**LCID PERMIT RENEWAL
BARNHILL CONTRACTING COMPANY
LANDFILL PERMIT NO. 43-E
McARTAN SITE**

Reference: **BARNHILL CONTRACTING COMPANY LCID PERMIT RENEWAL
PERMIT NO. 43-E**
Harnett County, North Carolina

In response to your comment letter dated November 10, 2008:

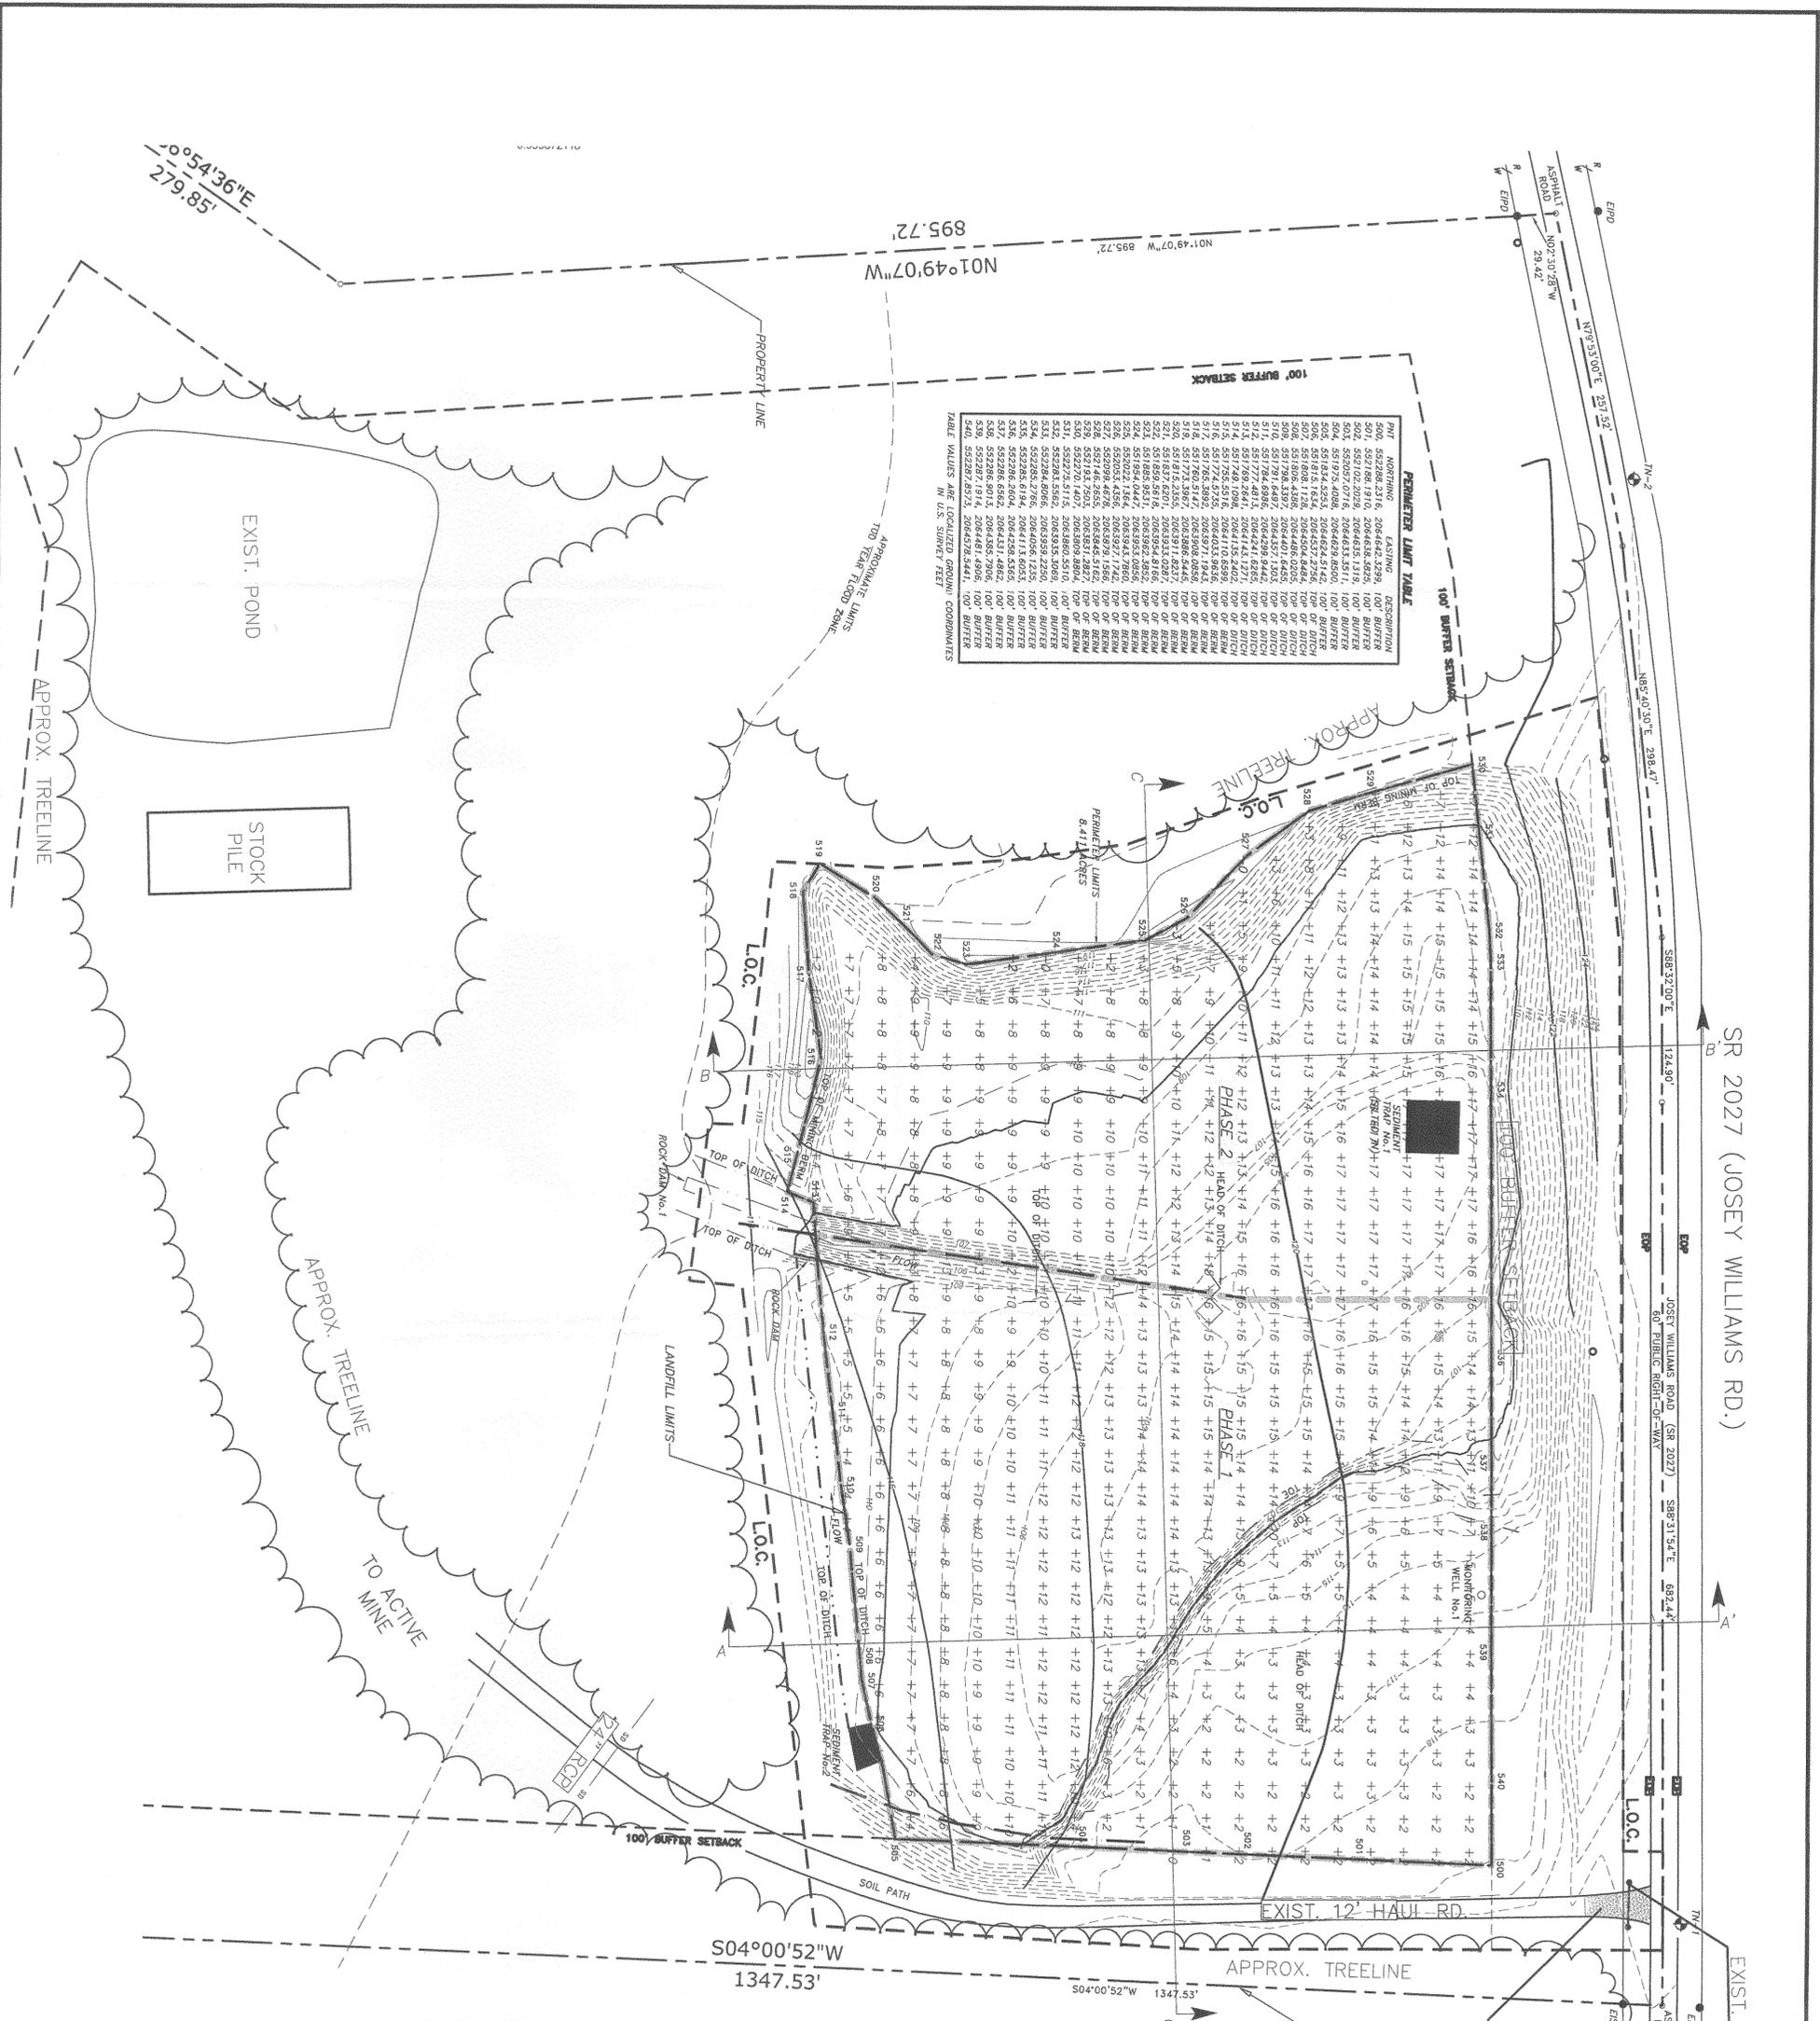
- I do not have access to any project correspondence between NCDENR and Crawford Design as to how the permit conditions in sections 8 were addressed I will place notes on the plan sheet 3 for the LCID operator to a follow based on those conditions.

PROJECT NO.	WG13.400
SCALE	VARIABLE
DATE	9/22/08
DRAWN BY	EJW
CHECKED BY	DWW/JSC
SHEET NO.	4

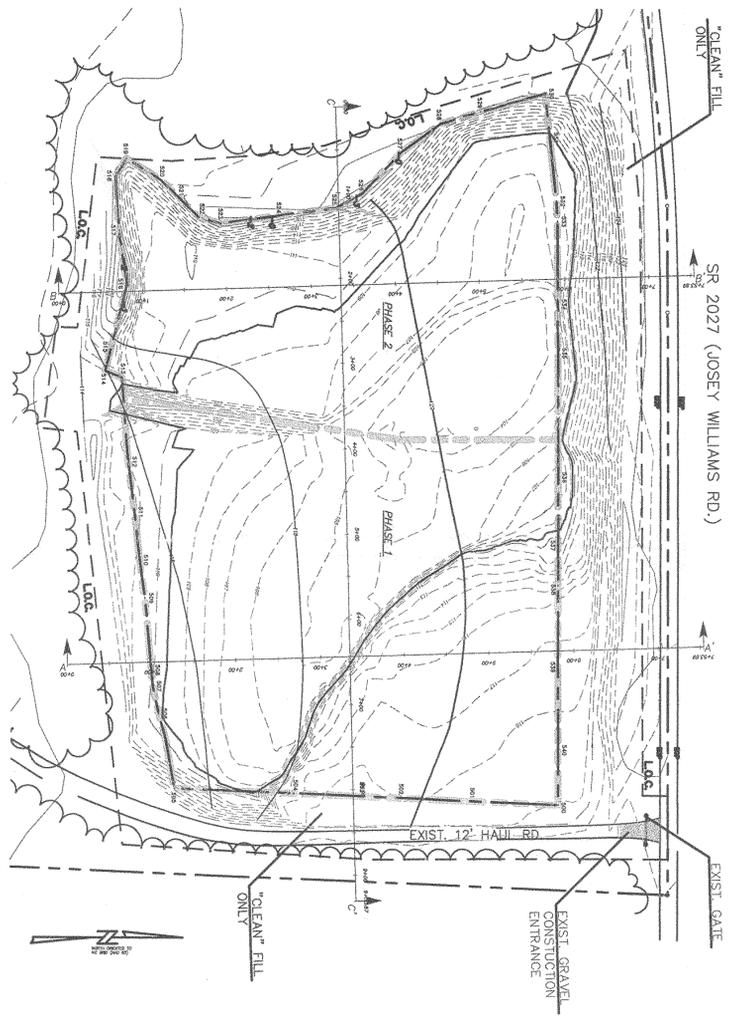
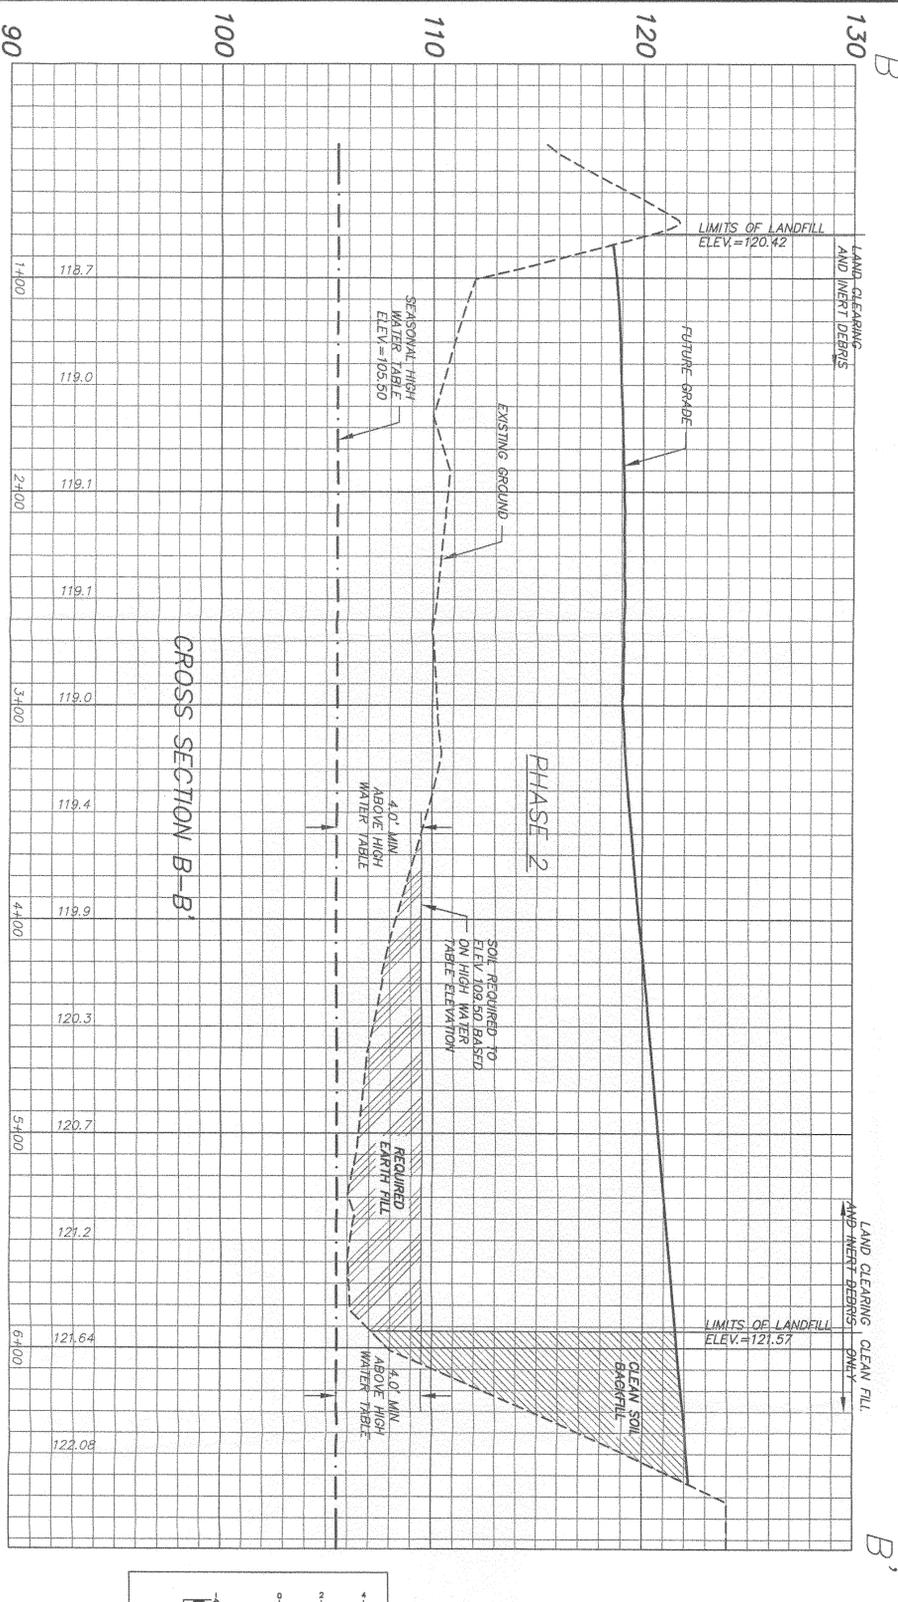
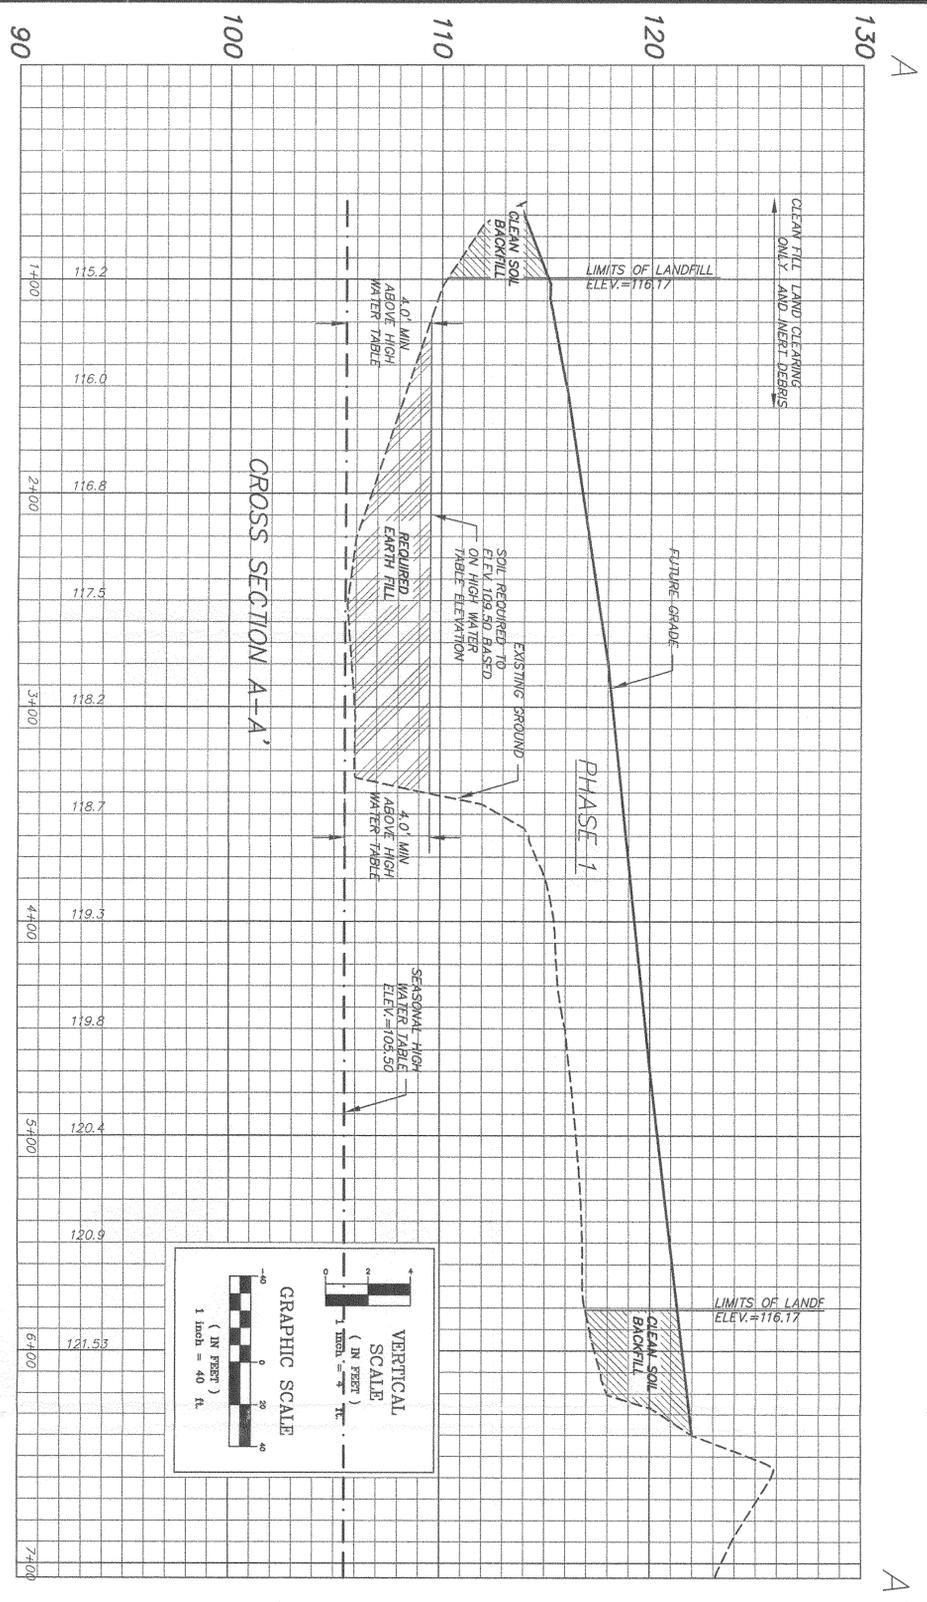
- Paragraph one was revised to "this permit renewal application".
- Sheets 4 and 5 off are revised to show the existing seasonal high water mark at elevation 105.5.

- The revised cross sections also shows the required four (4) feet of vertical separation which is required between any placed LCID waste and the seasonal highwater elevation. This area is required and is not considered as landfill capacity, rather is considered operational and required fill to be placed by the LCID operator.
